DESIGN [Signature]	DRAWN BY [Signature]	DART AEROSPACE LTD HAWKESBURY, ONTARIO, CANADA	
CHECKED [Signature]	APPROVED [Signature]	DRAWING NO. DSI 9294	REV. A SHEET 1 OF 1
DATE 05.03.04		TITLE STEP MODIFICATION	SCALE NTS
A	05.03.04	NEW ISSUE

DART SERVICE INSTRUCTION

TO AMEND DRAWING D350-591 REV. E OR F

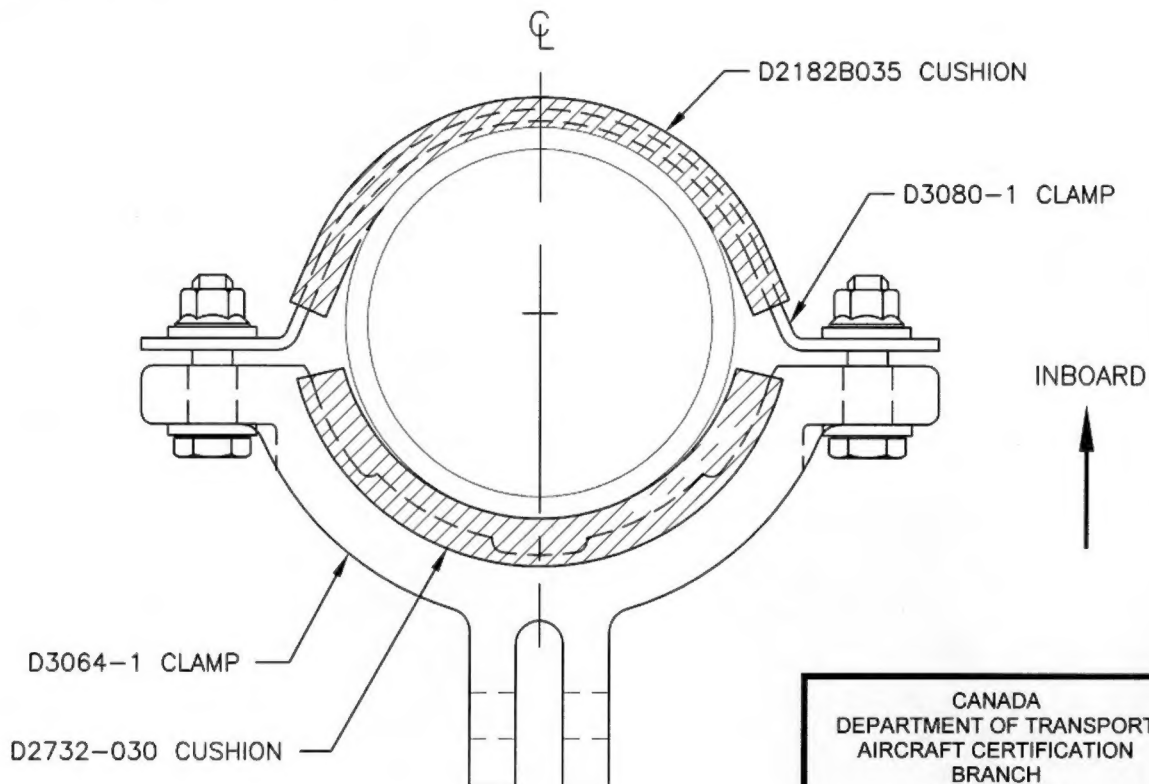
TO IMPROVE THE FIT OF THE D350-591-211/ -212/ -213/ -214/ -215/ -216 STEPS, IT IS ACCEPTABLE TO INSTALL D2732-030 RUBBER CUSHIONS UNDER THE D3064-1 CLAMPS AS SHOWN BELOW.
